Subject: Traffic Impact and Access Study Peer Review - Winchester North Residential development at 416 Cambridge Street, Winchester, Massachusetts under a Chapter 40B Comprehensive Permit Application

As requested, **Fay, Spofford & Thorndike (FST)** is pleased to submit this peer review of the *Traffic Impact Assessment Proposed Residential Development 416 Cambridge Street, Winchester, MA* (referred to from here on as the 'TIAS'). The TIAS was prepared by from VAI dated July 2015 in connection with the proposed Winchester North affordable housing development proposed at 416 Cambridge Street in Winchester, Massachusetts. During this peer review, FST's peer reviewer made a couple of visits to the project site and contacted the Winchester Police Department pertaining to recent crashes in the site vicinity between 2012 and 2015.

Pedestrian Crossing Enhancement for Consideration

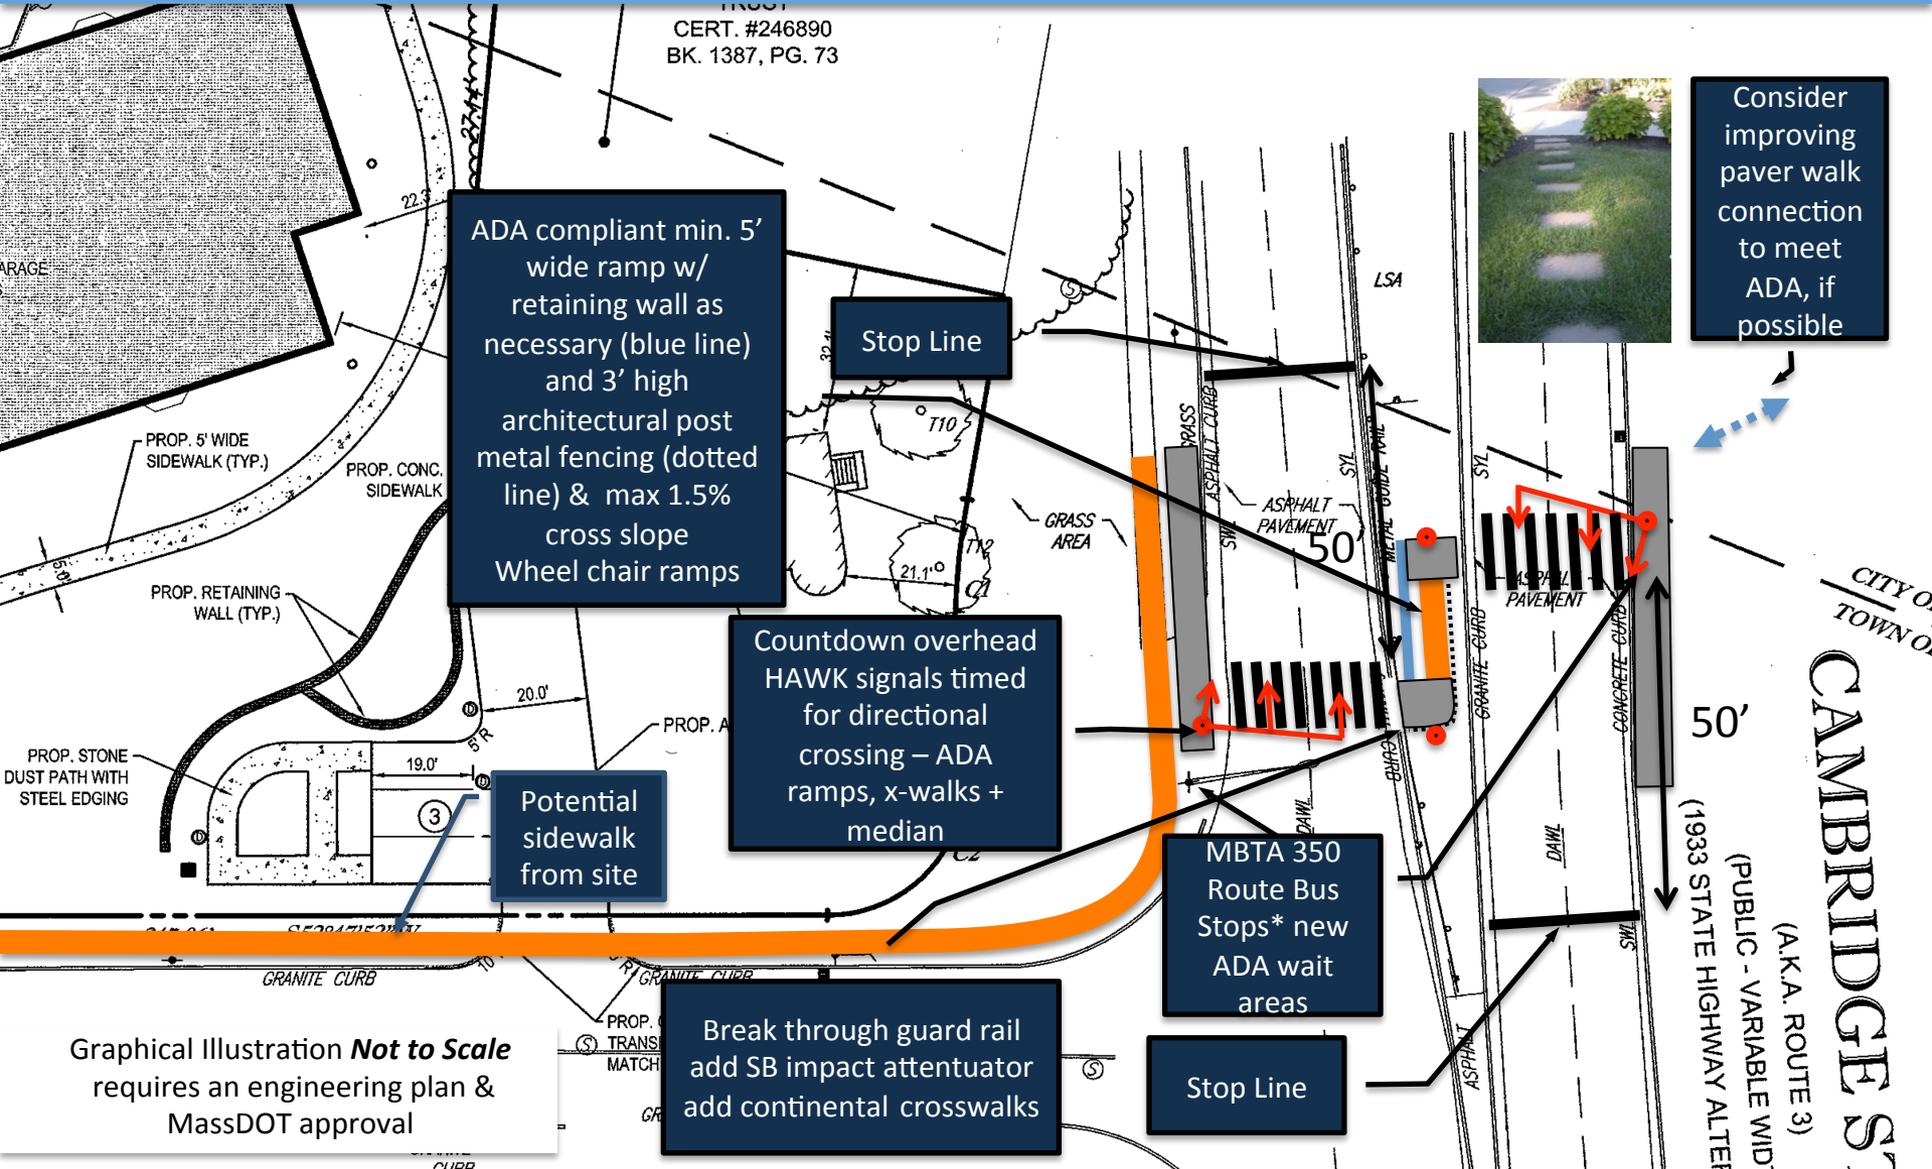
- 1) **Enhance the ability of pedestrians who live west of Cambridge Street at Winchester North, Ledges, or Woburn to safely cross it.** In accordance with the MassDOT's Healthy Transportation Directive, future Winchester North residents should have the ability to be able to walk to nearby MBTA Bus Route 350 with services to and from Alewife Garage and to do walk-in business at the Horn Pond Plaza. Doing nothing increases the likelihood that people who live at Winchester North may be injured trying to cross Cambridge Street. We suggest consideration of the following in consultation with MassDOT:

- Provision of an ADA compliant sidewalk in front of the site along the north side of Wainwright Road to the southbound MBTA bus stop.
 - Consideration of a pedestrian hybrid beacon-controlled 'Z' crossing of Cambridge Street, fully ADA-compliant, connecting the two bus stops with stop enhancements on Cambridge Street in front of the site and across the street. A rough concept sketch of a possible mitigation measure to be considered by the Applicant is attached with photos.

MassDOT may consider the need for a pedestrian hybrid beacon ‘or HAWK signal during the access permit process for the possible ‘Z’ crossing. A significant issue will be meeting warrants for adding a controlled HAWK crossing and constructing the ADA-compliant crosswalk via median work. In the future, at least 20 pedestrian crossings need to occur during a peak hour to warrant installation of a HAWK signal. HAWK signals are rarely seen in Massachusetts, so motorists and pedestrians would require a public information campaign to understand how they work. If installed, enhanced pedestrian access to the MBTA stops and the Plaza would also benefit the Ledges and nearby Woburn residents who may need to cross Cambridge Street.
